Staff Report

To: BOZAR
From: Jessie Earley, Town Planner III
Meeting Date: DRC, May 12, 2025
RE: 2 Teocalli Avenue (Felton), Secondary Review

PROJECT TITLE: Felton (2 Teocalli Avenue)

SUMMARY: Consideration of the application of **Edward L. Felton, Jr Trust Dated 12/28/1999** to site an addition to the primary building and to construct a cold accessory building to be located at 2 Teocalli Avenue, Lots 15 and 16, Block 7 in the R1 zone.

5/12/2025 DRC Revised Streetscape (shed dormers)

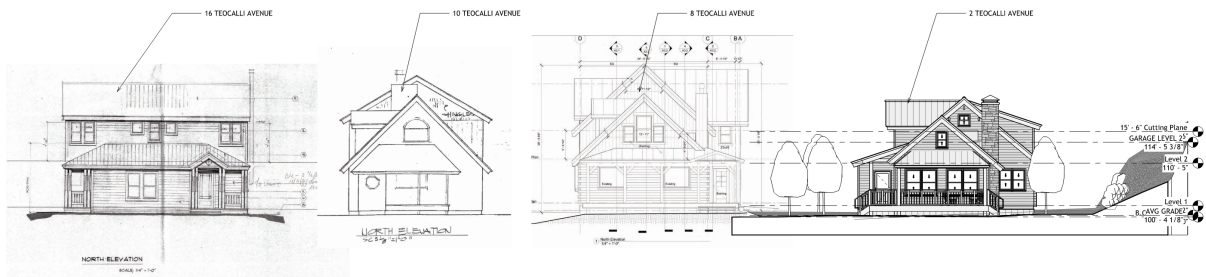
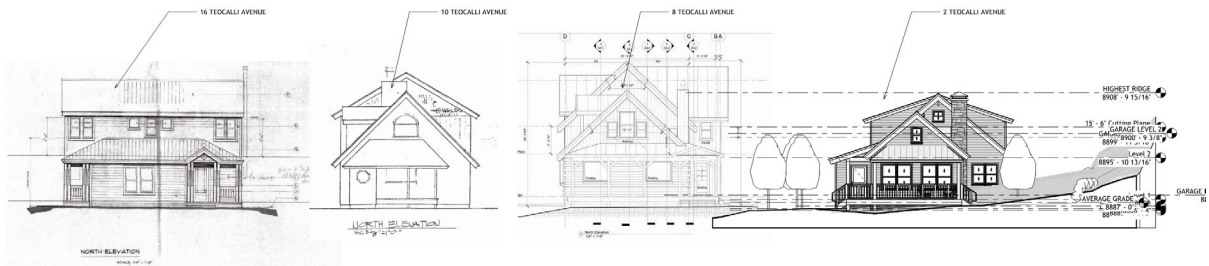
The Board should determine whether the overall scale and forms of the residence comply with the intents 4.25 and 4.26 (excessively similar or dissimilar) in relation to the neighborhood context.

GL	Staff Analysis	DRC Recommendation
4.25 Excessive similarity	The forms differentiate from the newer residences located in the 0 block of Teocalli Avenue per context GL 4.25.	Support
4.26 Excessive dissimilarity	Discussion is encouraged to determine if the additions, as proposed, are contemporary interpretations and variety or if the proposal is excessively dissimilar.	4/21 DRC: Members asked for revisions to the dormers based upon GL 4.46-4.47. The applicant has provided revisions.

Members asked for revisions to the chimney based upon GL 4.71. The applicant has provided revisions.
--	--	--

- Reduced the size of the west-facing dormer to be less than 30% of roof area.
- Changed the east dormer to a shed dormer to match the west dormer.
- Reduced the size of the chimney. Brought chimney in below roof to avoid odd roof extension. Moved stack slightly to north to provide code clearance.
- Changed railing to wood.
- Moved parking and snow storage onto property.

5/12 DRC: Proposed Site Plan

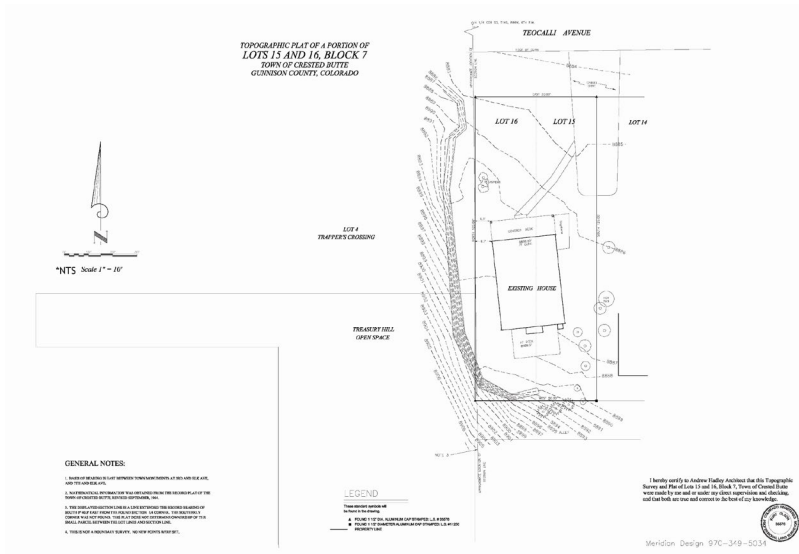
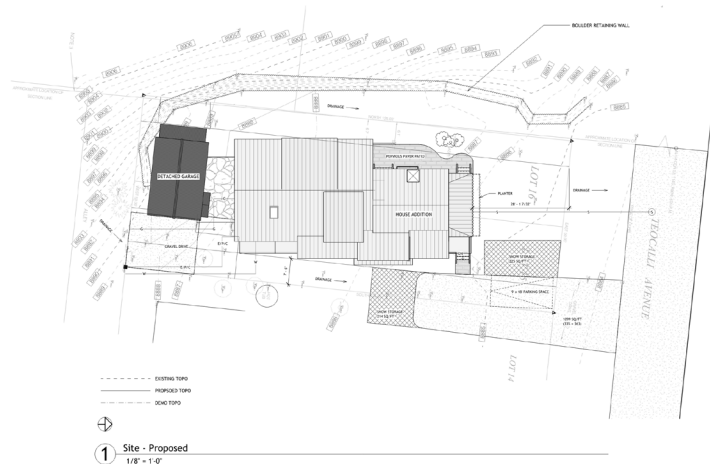
GL	Staff Analysis	DRC Recommendation
Topography	Topography has been provided. The lot is 8885' on the northeast corner stepping up in grade drastically to the west on the lot adjacent. Then the lot steps up from 8885' to 8901' on the southwest corner of the lot. The average grade for the purpose of measuring FAR will be 8887' for the primary building and 8889' for the accessory building. The applicant has put existing grade lines on the elevations, which is helpful.	4/21 DRC: Add information to the plans. Applicant has added natural grade lines to elevations to help confirm height and FAR.

2.8 Drainage	Drainage information has been provided on the site plan. It shows drainage to the north and northeast corner of the lot. The drainage will need to be finalized with the Building Official and Public Works department to ensure that it does not negatively impact the neighbors to the east.	Support
Easements	None shown.	NA

2.16 Substantial landscaping	The plan is fairly minimal. Provision of a final landscape plan will be required for review and approval prior after permitting prior to a CO, if changes are proposed. There is an existing retaining wall on the west and south. This is to remain,	Support

portions of this wall on the west are on the neighboring property.	
2.18 Mature trees	Confirmation is needed from the applicant to determine if any trees would need to be removed from the site. There is a cluster of 3 aspen trees on the west side of the lot. There is one tree on the southeast corner of the lot. Then, there are two trees in the alley to the south.	Provide information.

2.19 New trees	There are no new trees noted on the site plan. This appears to conflict with GL 2.19. Two street trees are encouraged, potentially on the northwest corner.	Provide street trees to meet requirements.

2.16 a./ 2.20 Native plantings	Disturbed areas have not been called out for what will be planted but must be. Native plantings are encouraged by the GL.	Provide information

2.7 Snow Storage	Snow storage is provided onsite and now meets the 33% requirement of the areas to be plowed. However, it is not adjacent to these areas for the area in the rear (south).	Provide information. The applicant has shifted the areas.

5/12 DRC: Revised North Elevation

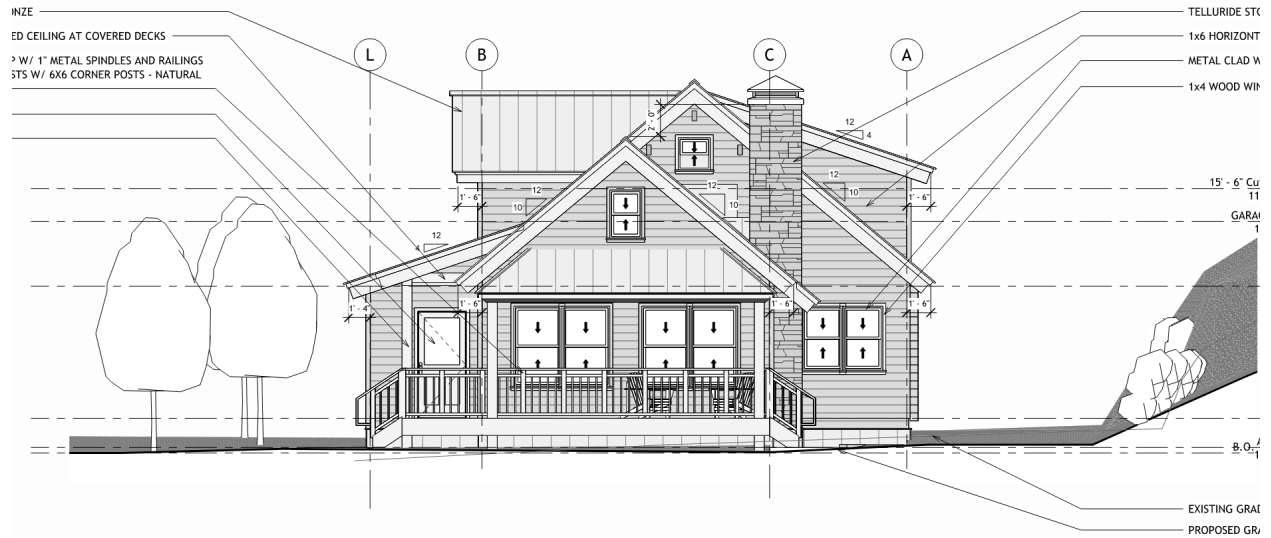
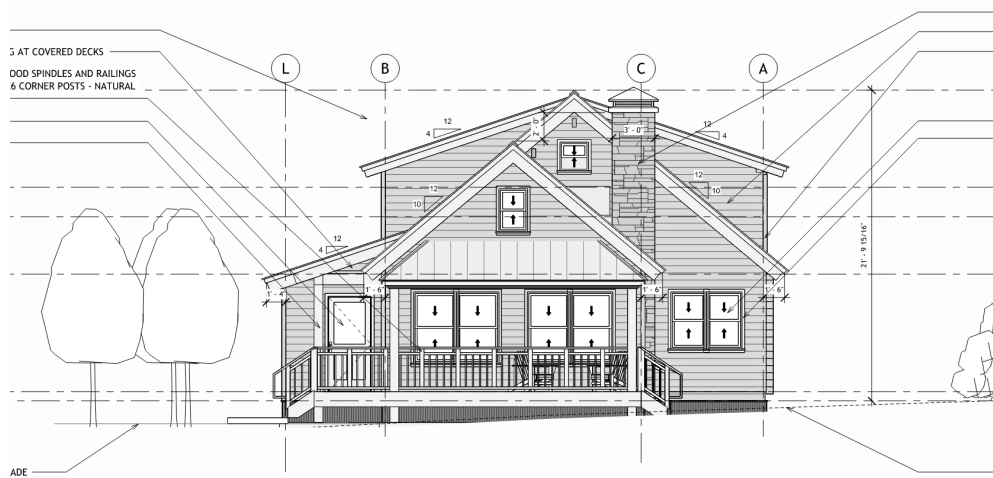
GL	Staff Analysis	DRC Recommendation
4.46 Dormers in new construction	West shed: There is a dormer proposed on the west elevation of the existing building module. It is a shed dormer. Shed dormers are not the dominant form in this neighborhood, as seen in the streetscape. Staff finds support.	4/21 DRC: Members did not support the mix of dormers. So, the applicant revised the proposal for two shed dormers.

<p><u>East shed:</u> There is a shed dormer proposed on the east elevation of the existing building module. Support</p> <p>GL 4.46 c suggests that dormer types should not be mixed on a module when highly visible from the street. So, the gable dormer was changed to a shed dormer on the east.</p>

4.47 Dormers	<p><u>West shed:</u> The dormer steps down 8" from the ridge of the module but appears large on this elevation.</p> <p><u>East shed:</u> The dormer steps down 8" from the ridge of the module and achieves subordination.</p> <p>a. <u>West shed:</u> The dormer, as proposed occupies 31.9% of the roof, which is in conflict with this GL that requires 30%.</p> <p><u>East shed:</u> The dormer, as proposed occupies 20% of the roof, which is supported.</p> <p>b. <u>West shed:</u> The dormer is lower than the ridge. There is a section of roof beneath, support.</p> <p><u>East shed:</u> The dormer is lower than the ridge. There is a section of roof beneath, support.</p> <p>c. NA.</p> <p>d. <u>West shed:</u> The dormer as proposed is in the middle 70% of the roof form.</p> <p><u>East shed:</u> The dormer is proposed within the first 1/3 of the roof, not the middle 70% as the GL suggests.</p> <p>e. <u>West shed:</u> The vertical wall of the dormer is 5'2". This must be reduced to 4' to meet the intents of the GL.</p> <p><u>East shed:</u> The vertical wall of the dormer is 4'3", which also must be reduced slightly to meet the intents of the GL.</p>	<p>4/21 DRC: Members did not support the mix of dormers. So, the applicant revised the proposal for two shed dormers.</p> <p>Members also asked for the dormers to be revised to ensure compliance with the 30% requirement and 4' vertical wall.</p>

5/12 DRC: Revised West Elevation

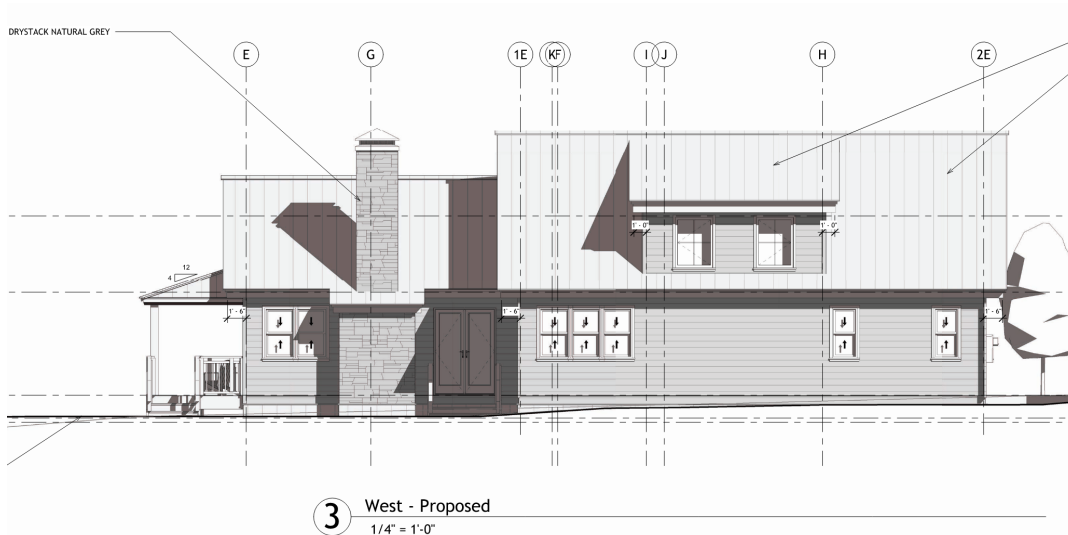
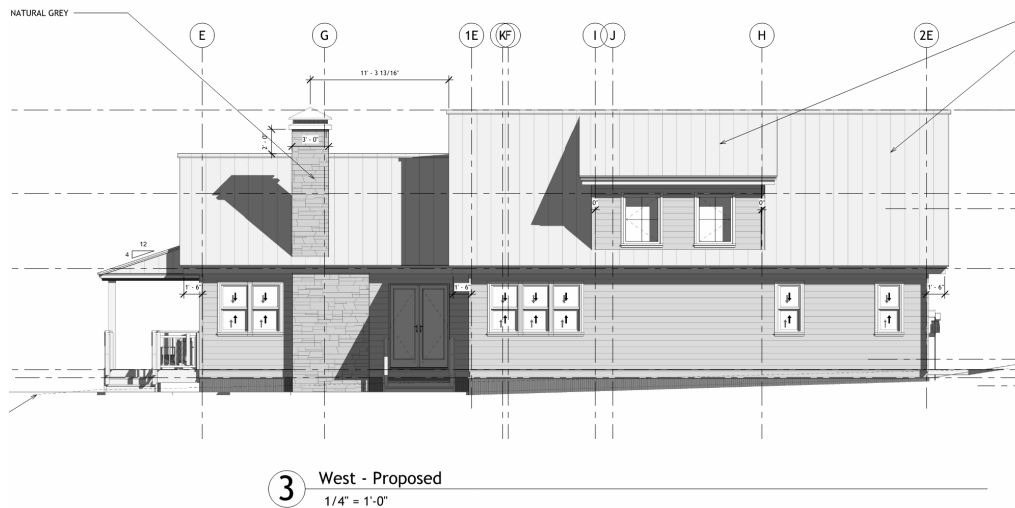
4.58 Groupings of 2 or more windows	<p>All three packs of windows must have 3.5" of dividing trim because this is a core zone. These windows cannot be mulled. This must be revised for the three pack on the west elevation.</p> <p>The two packs on all elevations appear to meet the intents of this GL.</p>	4/21 DRC: Provide 3.5" of trim for west three pack of windows

5/12 DRC: Elevations glazing

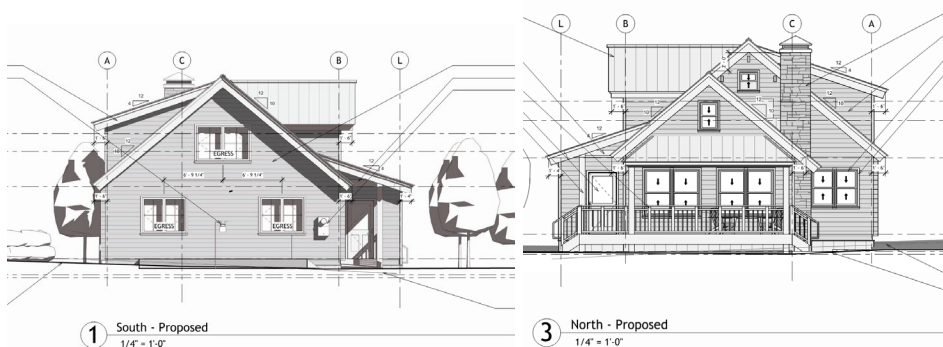
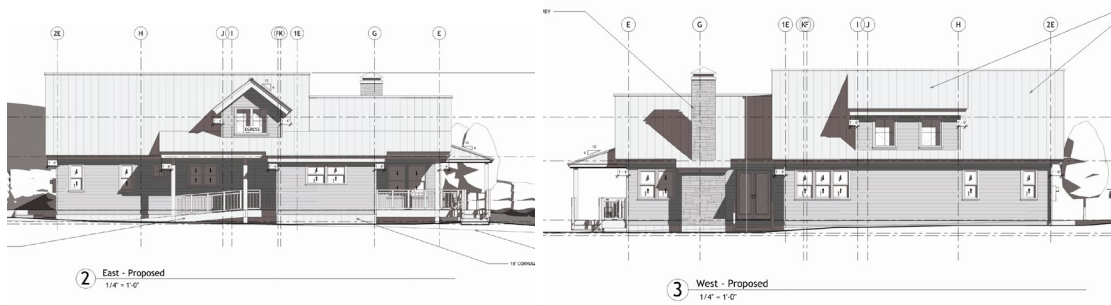
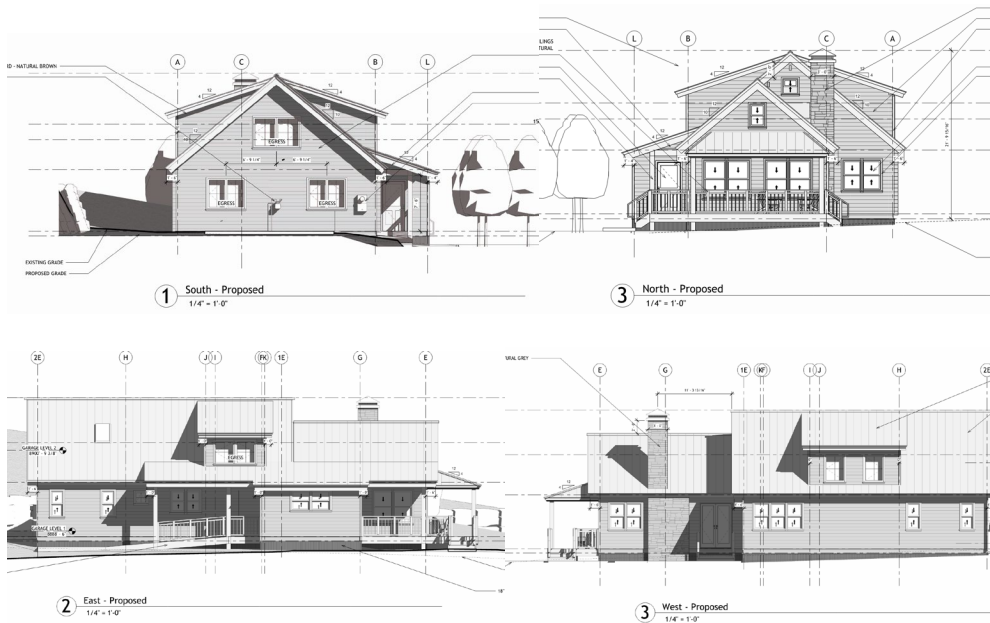
GL	Staff Analysis	DRC Recommendation
4.53/5.43 Window to wall ratio	<p>Window to wall ratios along the front elevation (north) proposes 108.6 sf of glazing/576.16 sf wall space, which is 18.8% window to wall.</p> <p>The building exists with two large picture windows and door glazing on the front elevation and two triangular windows and a rectangle within the gable.</p> <p>The first floor proposes three, two packs and door glazing (85.9 sf). There is a single window in each of the gables (4.01 sf and 5.01 sf), which meets the intents of the GL.</p> <p>On the west elevation there are currently no windows. This proposal is for two single windows, a three pack, a two pack and door glazing on the first floor. Then, there are two single windows on the second floor.</p> <p>On the east elevation, there are two, two packs that are existing. The proposed elevation is for three, two packs of windows and three single windows on the first floor, and a two pack on the second floor.</p> <p>The south elevation proposes two, two packs on the first floor, and a two pack within the second floor gable.</p>	Support

4.54 Vertical emphasis	<p>Some windows are proposed as two over two, and others are proposed as a one over one. One style should be chosen. Windows are double hung and double hung style casement windows, which is consistent with historic homes. A window schedule has not been included but should be.</p> <p>The windows are proposed as casement and double hung, which is supported by GL 4.54 a. Window operations have been noted on the plans. These windows</p>	4/21 DRC: Choose one style of window one over one or two over two.
